## Council Sub-Committee on Transportation at Obey Creek

*Sub-Committee Meeting – February 26, 2015 from 4:00-6:00pm  
in the Planning conference room (third floor) of Town Hall*

**Date:** January 06, 2015  
**To:** David Bonk, Kumar Neppalli, PE  
Town of Chapel Hill, North Carolina  
**From:** Bill Schultheiss, PE  
**Re:** South Columbia Street and Otey's Road Safety Review and Concept Development

Obey Creek –  
Detailed Transit Analysis Update

Existing pedestrian and bicycle access and safety challenges

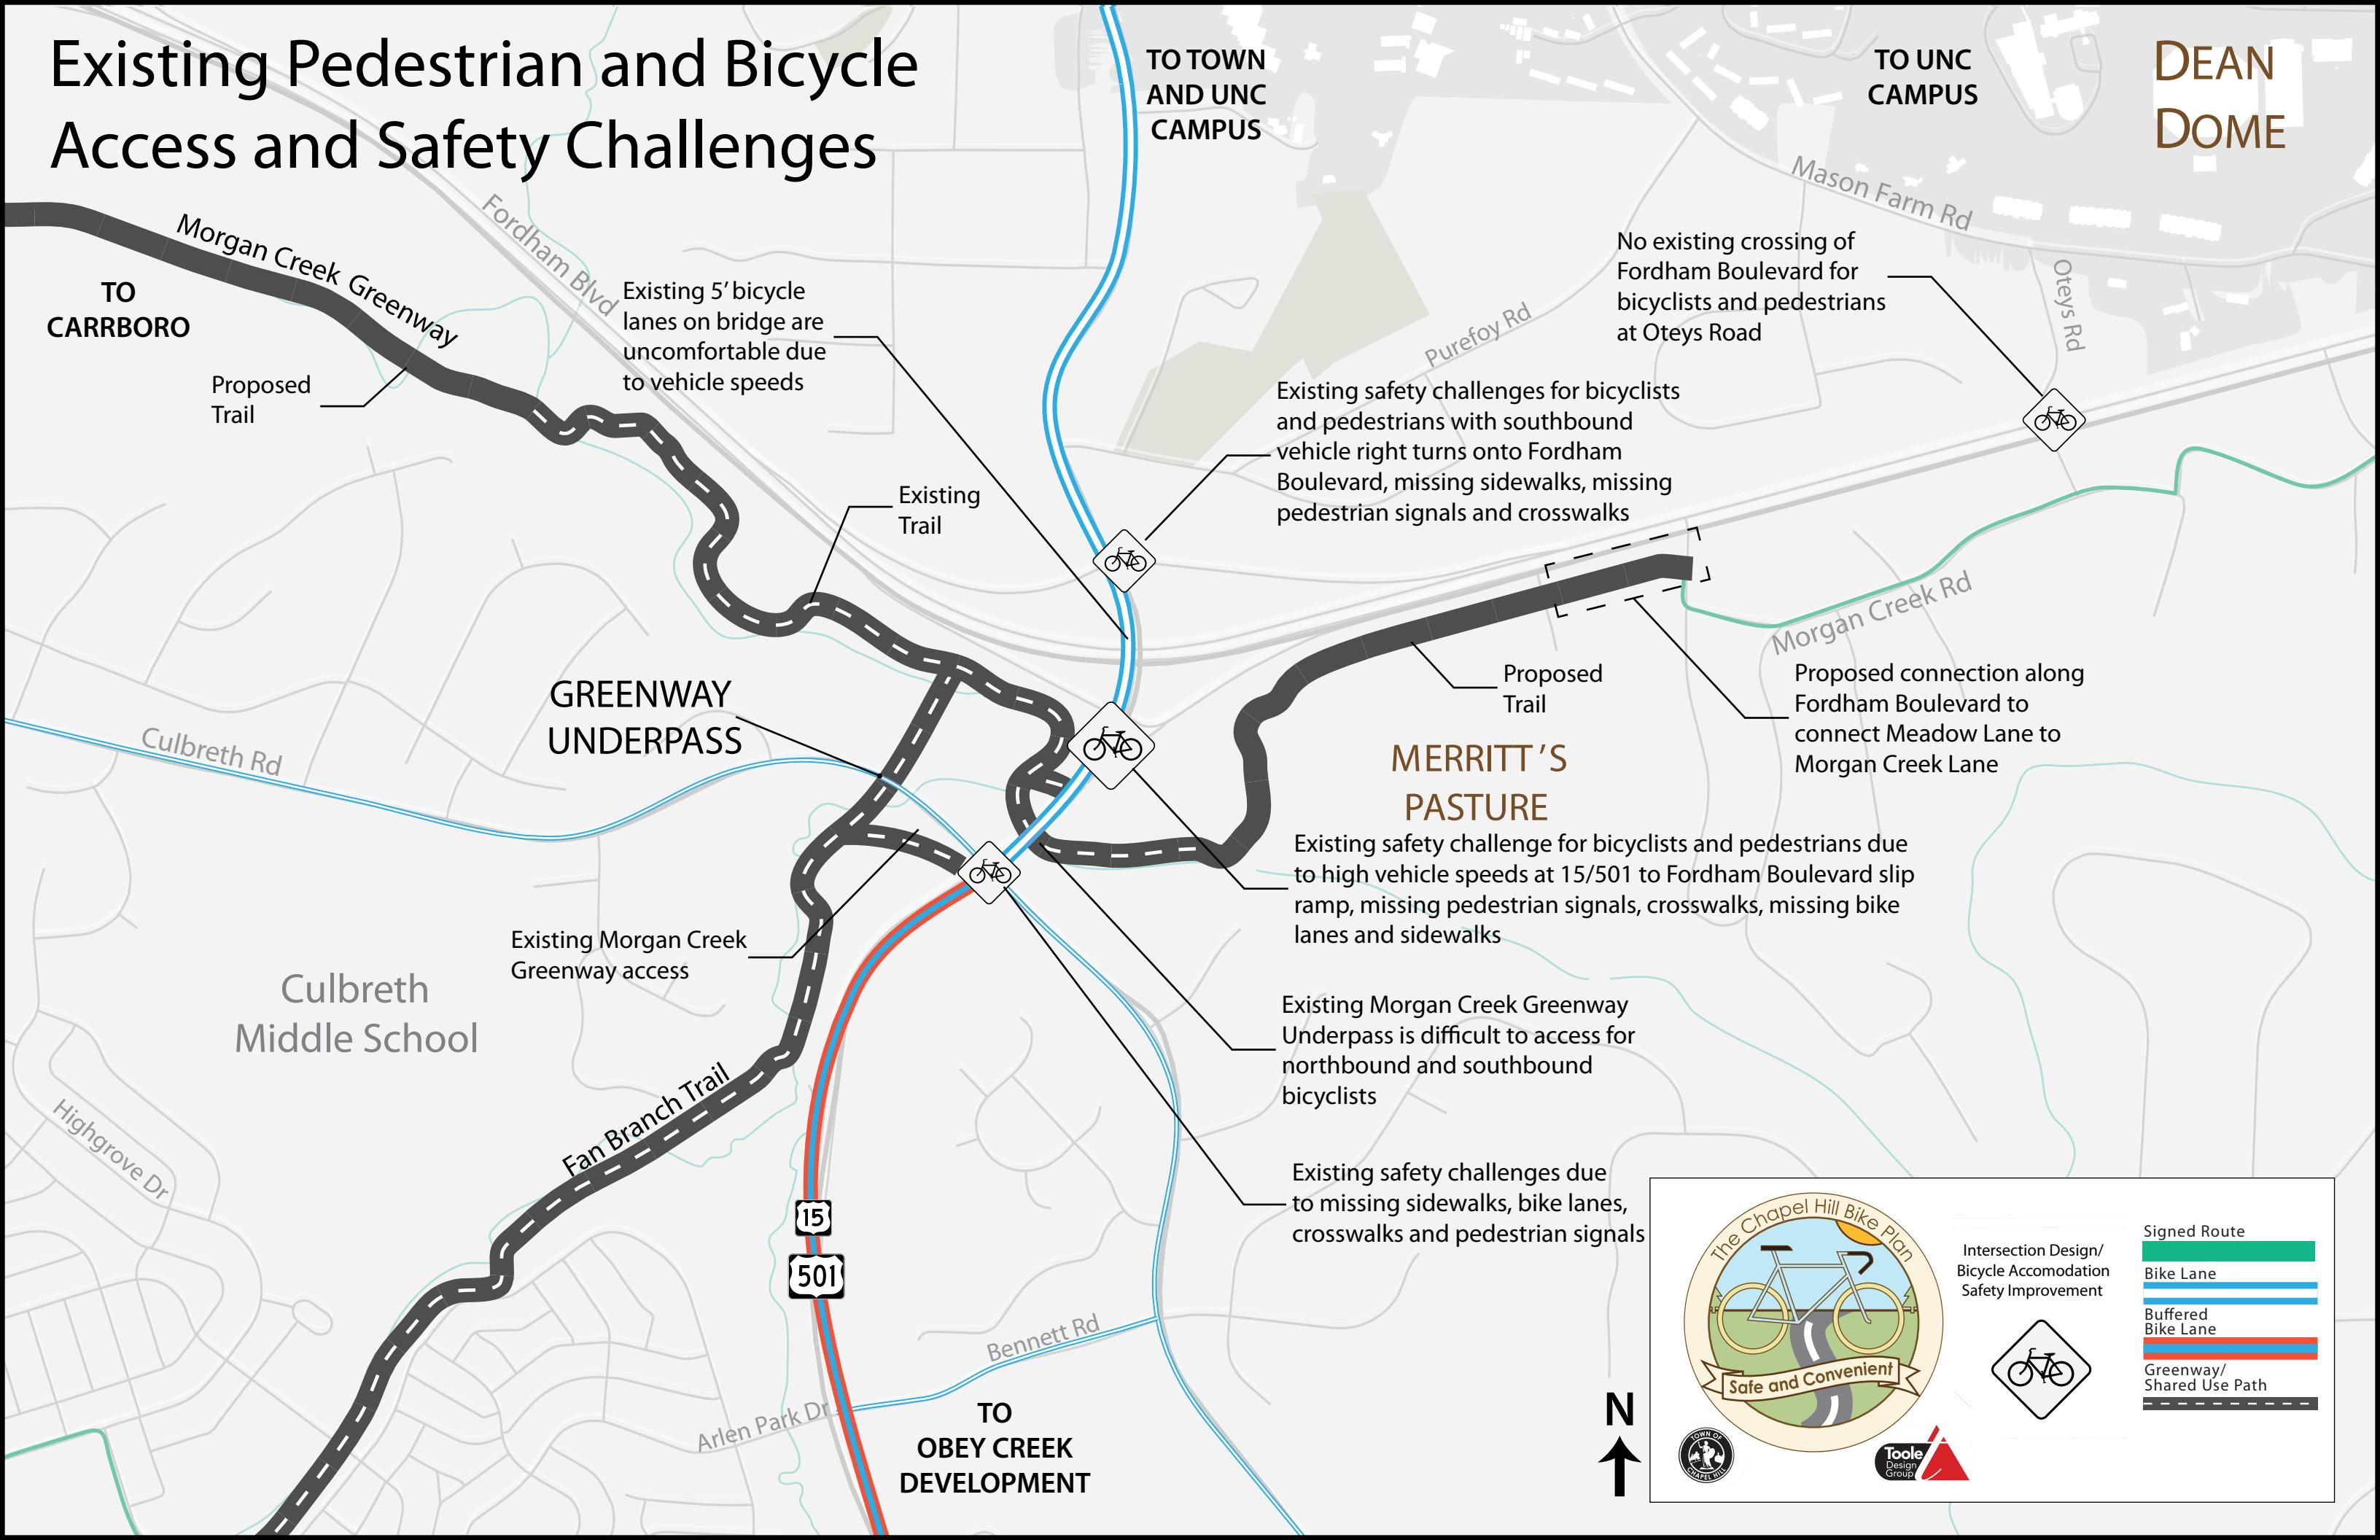
- Absence of street lighting along South Columbia Street
- Missing sidewalks along the east side of the street south of Fordham Boulevard
- Free flow right turn lane that allows high speed turns for northbound right turn onto Fordham Boulevard
- The size of the intersections increase exposure of bicyclists and pedestrians to turning traffic and allow traffic to turn at higher speeds
- Incomplete trail connections through Merritt's Pasture to allow alternate route to UNC Campus via Morgan Creek Road
- Missing crossings to allow pedestrians and bicyclists to cross South Columbia Street
- Unclear delineation of bicyclists path through merging areas reduces clarity of right-of-way at start of right turn lanes

The deficiencies identified in Exhibit 1 are based on direct observation by TDG staff, a review of the proposed KHI alternative, and input provided from the public through the Town and University Bike Plans.

Kimley-Horn and Associates, Inc. intersection design concept for the northern intersection of South Columbia Street at Fordham Road

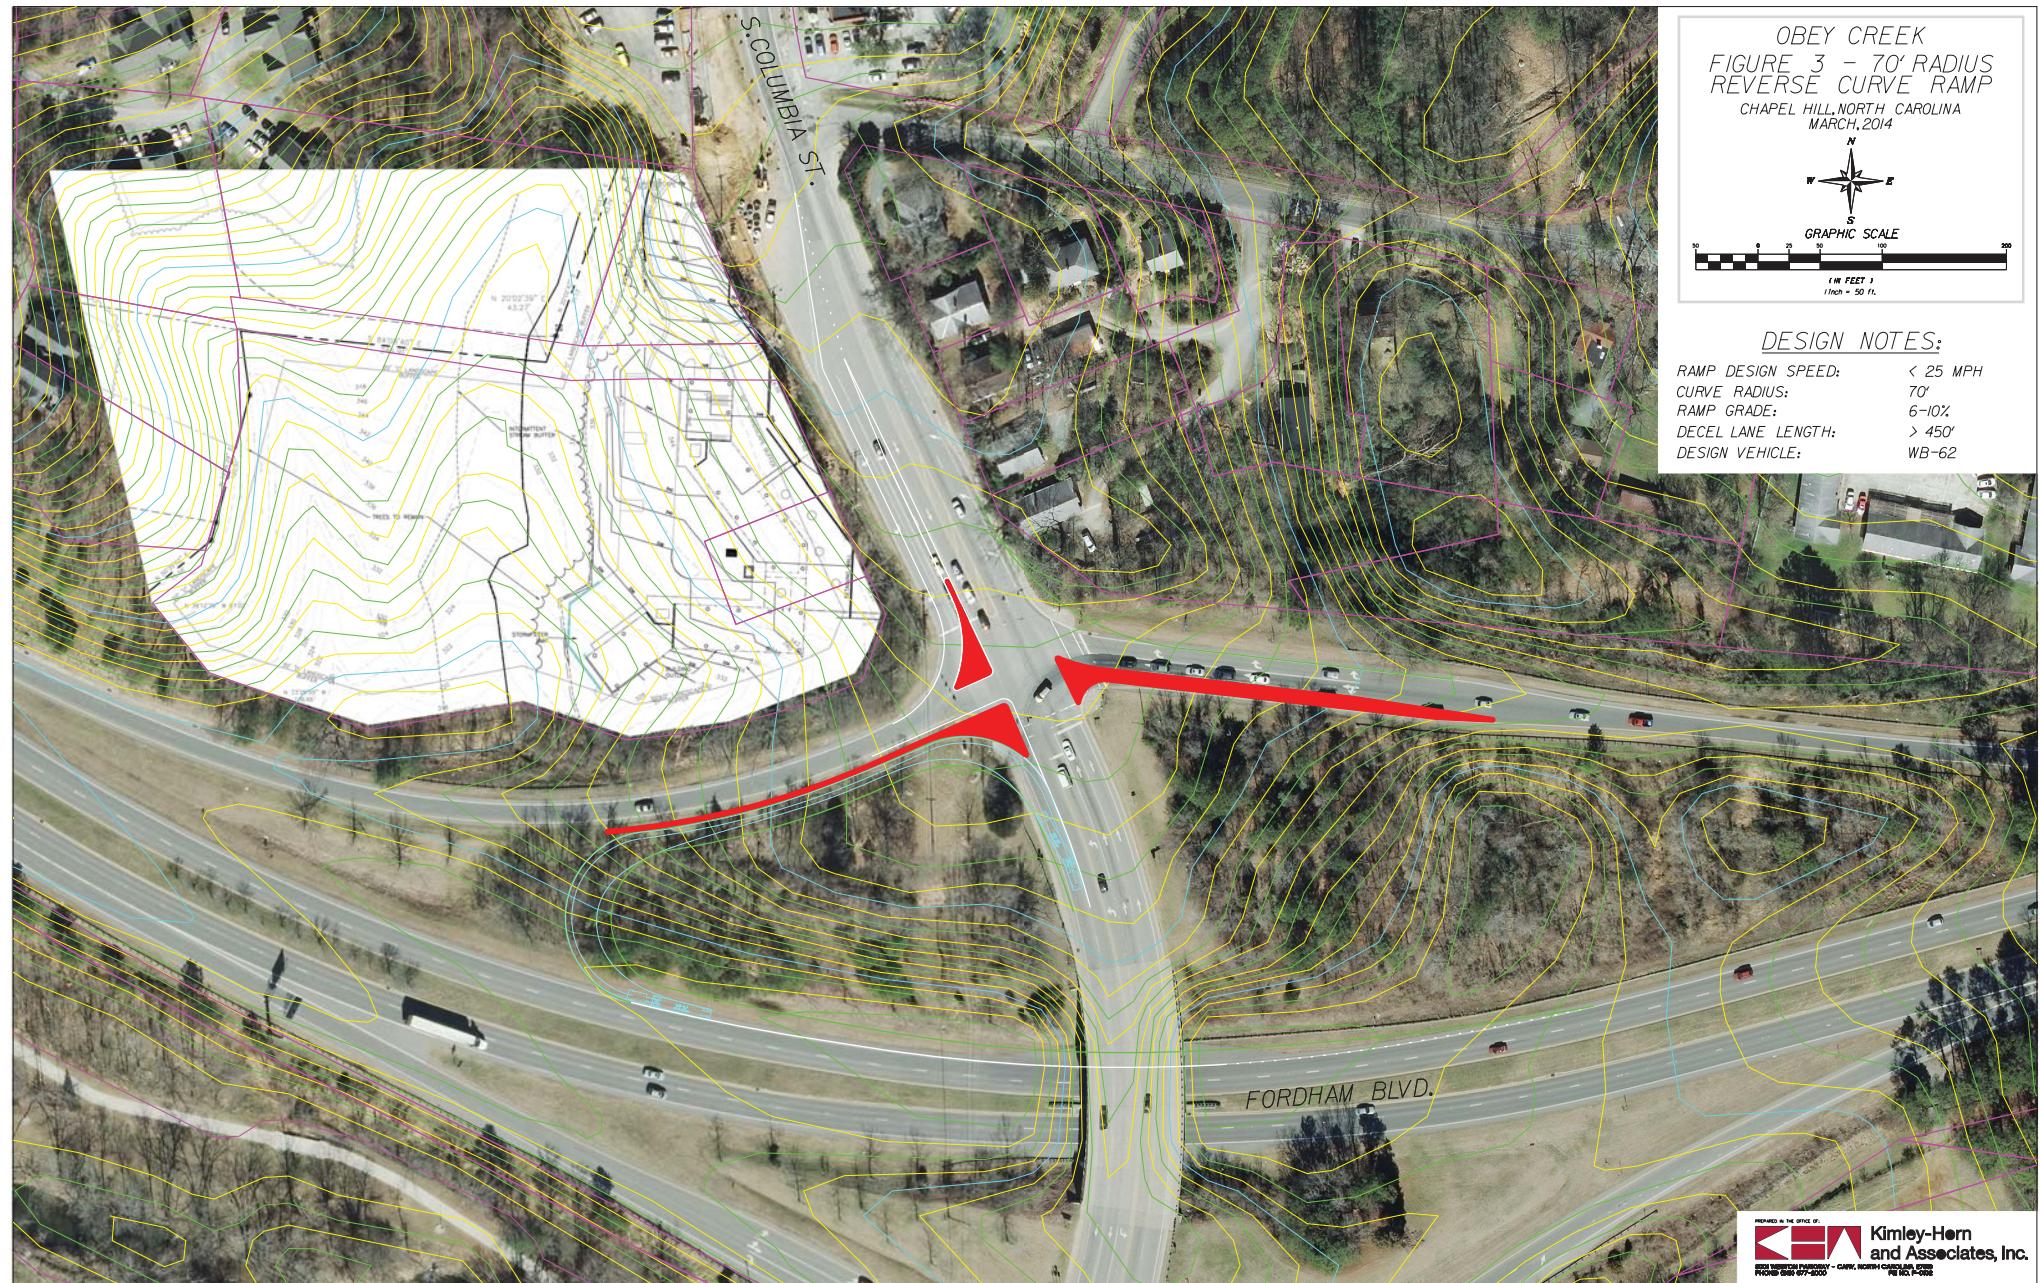
Kimley-Horn and Associates, Inc. (KHI) developed three concept designs at the northern intersection of South Columbia Street at Fordham Boulevard. These exhibits all provide variations of free flowing off-ramp approaches to South Columbia Street, with the only difference being the radius of curvature for the off ramp from Fordham Boulevard. For purposes of this review, only Figure 3 is assessed. ***The KHI design is attached as Exhibit 2.*** This figure provides additional geometric design detail as compared to the HNTB alternative 2 graphic. The design recommends the provision of:

- free flowing southbound right turns onto Fordham Boulevard
- free flowing southbound right turns onto South Columbia Street to reduce motorists delays and to ensure vehicles do not back up onto Fordham Boulevard.

The design conforms to AASHTO guidelines but fails to consider the impacts on pedestrians and bicyclists by emphasizing motorist mobility over the mobility and safety needs of other users. It is not an appropriate design for an urban area where bicyclist and pedestrians are routinely present on the roadway and the crossing has been previously identified as a major barrier to non-motorized travel. This is an increasingly urbanizing area in close proximity (approximately 1 mile) to the heart of the Town of Chapel Hill and the UNC Campus.

The free flow ramps are designed to accommodate a WB-62 tractor trailer truck turning into its own travel lane without encroaching onto other lanes to maintain the free flow capacity of the lane. This results in the need to provide a 60 to 70 foot radius turn which allows smaller vehicles to turn at higher speeds, lengthens crossing distances, and flattens the viewing angle between the turning motorist and approaching bicyclists and motorists on the South Columbia Street. The combination of these factors reduces safety for pedestrians and bicyclists and on the South Columbia Bridge, reduces safety between motor vehicles that may need to merge across higher

speed traffic to change lanes<sup>4</sup>. The concept does not provide any detail for existing safety deficiencies for pedestrians and bicyclists could or would be addressed. This design is not recommended for implementation without further modifications.

sheet name:  
S. COLUMBIA AT  
FORDHAM BLVD  
WESTBOUND RAMPS  
drawing number  
**SK-1**  
sheet number  
1 of 13

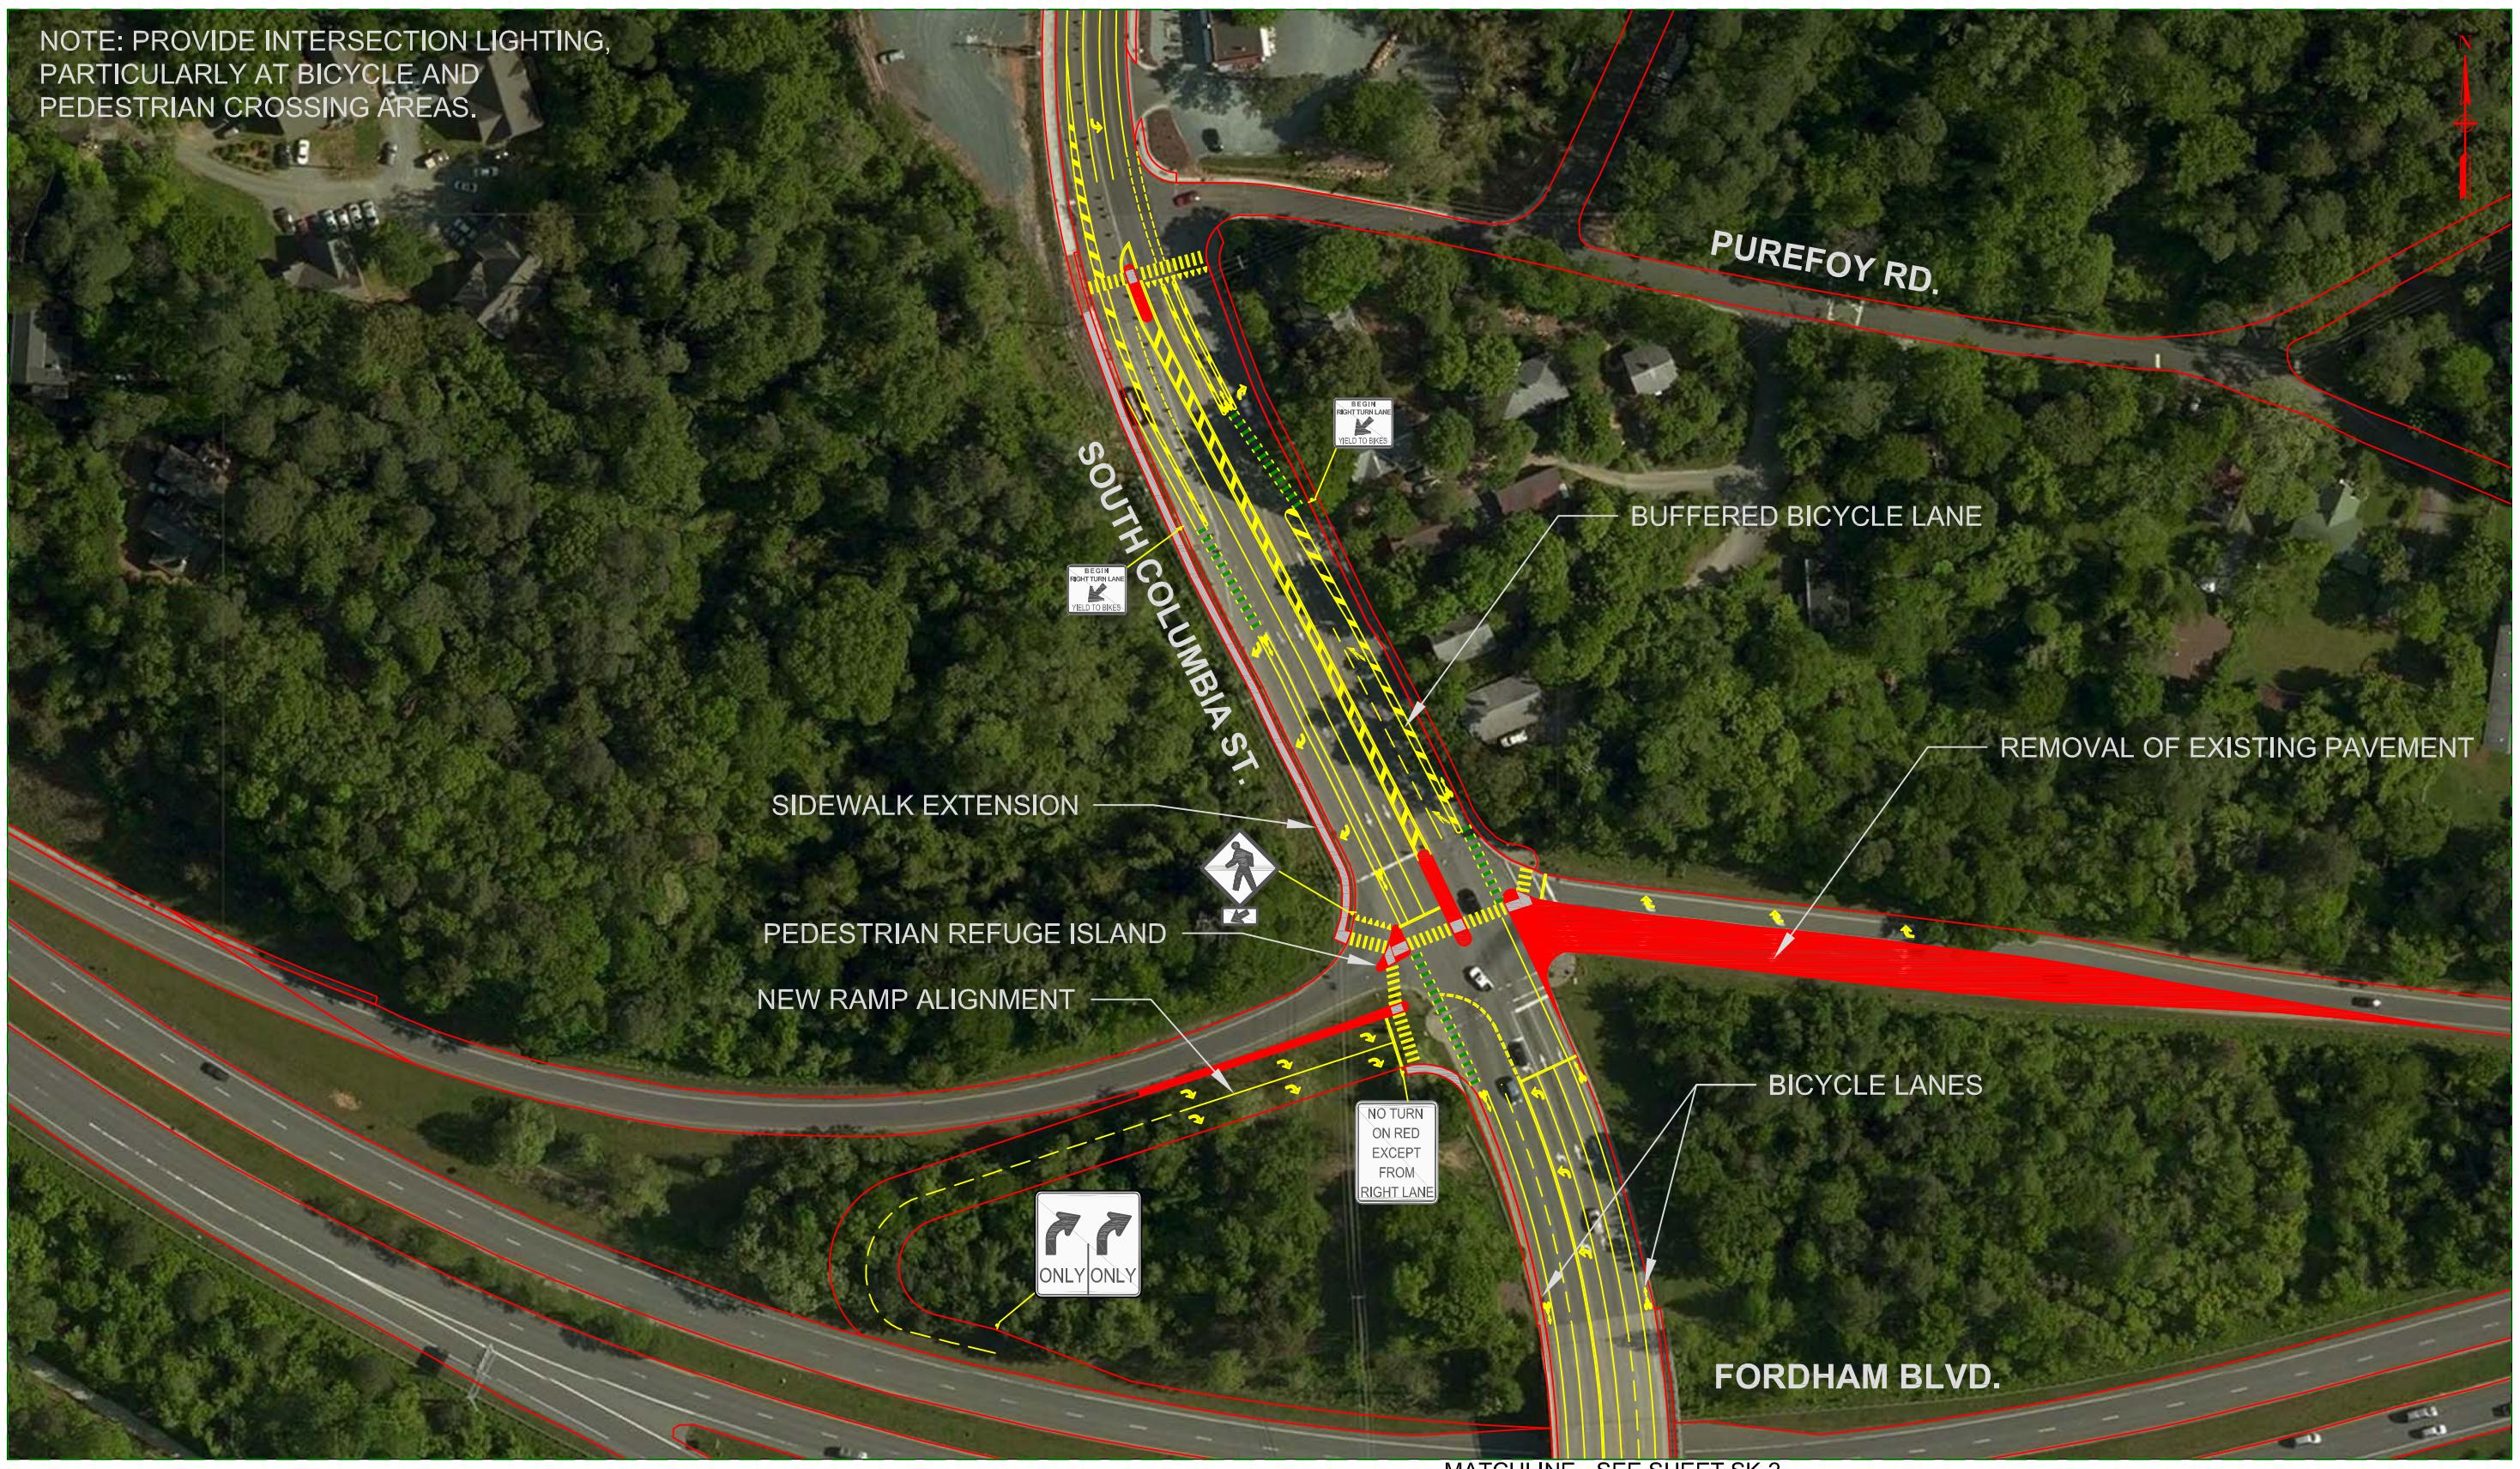
Alternative 1 depicts modest changes to the KHI design. The slip ramp designs remain in place for the southbound and northbound on-ramps to Fordham Boulevard. Adjustments to curbs are recommended to remove free flow traffic from the proposed westbound to southbound off ramp.

- Signal, stop control, or yield control for each on and off ramp is recommended in that prioritized order of consideration to ensure pedestrians and bicyclists have safe crossing opportunities;
- Modify intersection geometry for the northern intersection of South Columbia Street at Fordham Road to:

- allow a WB-62 to utilize the full width of the receiving roadway for turns, (recognizing this is a small percentage of the traffic);
- consider restriction of right-turn-on red for trucks which will need larger gaps in traffic if the dedicated receiving lane is not provided;

- to reduce likelihood vehicles queue into the through lanes on Fordham Boulevard<sup>5</sup> the westbound to southbound off ramp provides a double right turn lane (shown on concept); this may require trucks to control both lanes to make the right turn;

- It may be further necessary to lengthen the deceleration lane from Fordham Boulevard east of the the South Columbia Bridge. It appears space is available if the travel lane can be located in close proximity to the existing bridge support column.

- A median refuge is provides for the new northern crosswalk;
- Modify intersection geometry for the southern intersection of South Columbia Street at Fordham Boulevard;
